UNITED STATES PATENT AND TRADEMARK OFFICE

10/786,787

Office Action Summary

DETAILED ACTION

Figure 6-38: SEM of a released 6-DOF IMU.

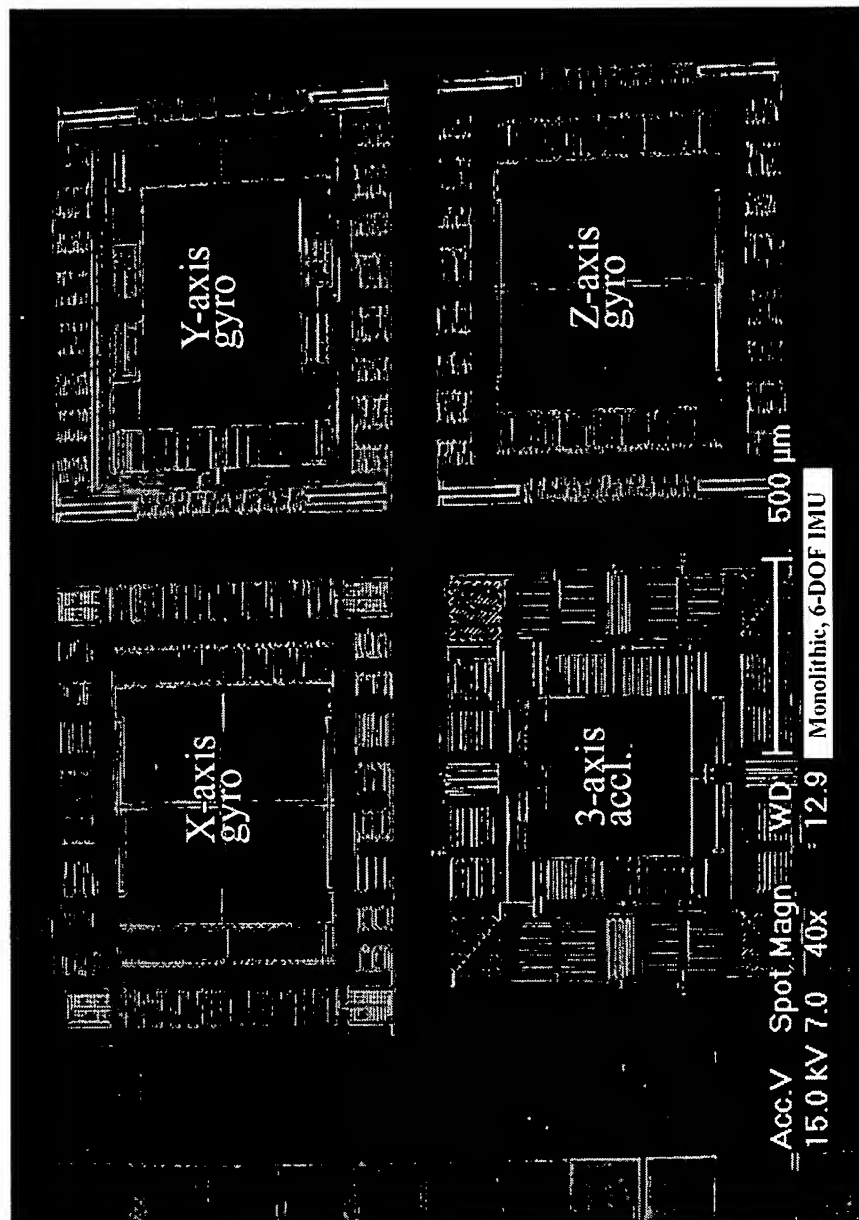
Figure 6-38 on page 194 of the thesis, taken in conjunction with the text of the thesis, clearly shows a three-axis accelerometer chip having a plurality of comb finger sets with one set for each of three orthogonal axes, where all are on a membrane layer portion of a single crystal substrate, and a proof mass support by at least one flexure, with comb fingers on the proof mass, where the flexure connects the proof mass to the membrane. A pre-amplifier is shown on-chip in Figure 6-24 on page 126. The comb finger sets provide fully differential capacitive bridges for all axes, and are formed of metal/dielectric stacks disposed on the membrane layer, where the metal may be electrically connected or isolated from the membrane layer, with the membrane layer having a smaller cross-section than the metal area of the fingers (Figure 3-20, page 51; and Figure 6-37, page 194). The structure for Z-axis sensing is spring decoupled from a rigid frame used for supporting comb fingers for x- and y-axis sensing. The membrane layer is further taught as being less than 100um thick on page 18.

9. If not anticipated by the text and Figure 6-38 of Reference W, it would have been clearly obvious to one of ordinary skill in the art to take the technology presented with respect to the gyroscope structure and apply it to the fabrication of a 3-axis accelerometer as shown in Figure 6-38 and page 194 of the thesis text.

10. Applicant's remarks have been read and considered, but are unpersuasive. Applicant's argument that no details can be discerned by the very poor copy of Figure 6-38 is not well received, since a similar copy made by the Examiner, and attached to this action, clearly shows the same structure as shown by applicant's Figure 7A that applicant relies upon to describe the invention, and the poorly printed copy supplied by the Examiner is no where as clear as the same figure from which it was copied. In this figure, it is clearly obvious to one of ordinary skill in the art, that there is a proof mass in the middle supported by flexures, for example, in the corners, and a plurality of sets of comb fingers for sensing motions. One of ordinary skill in the art, having read this thesis, would clearly recognize these as capacitive comb fingers. Applicant's argument that the thesis is primarily directed to gyroscopes and not accelerometers is similarly unpersuasive, since the paper does mention and show a 3-axis accelerometer. Further, gyroscopes and accelerometers are not so different as to render one skilled in the art of gyroscopes, as shown in the thesis, incapable of applying the same structural built technology presented in the thesis to EACH axis of a three-axis accelerometer. Applicant further admits in his original paragraph [0054] that those having ordinary skill in the art will appreciate that the structure for x-y sensing can be disposed inside the frame. Thus, applicant recognizes the ability of one of ordinary skill in the art to arrange the elements with respect to one another to sense the appropriate
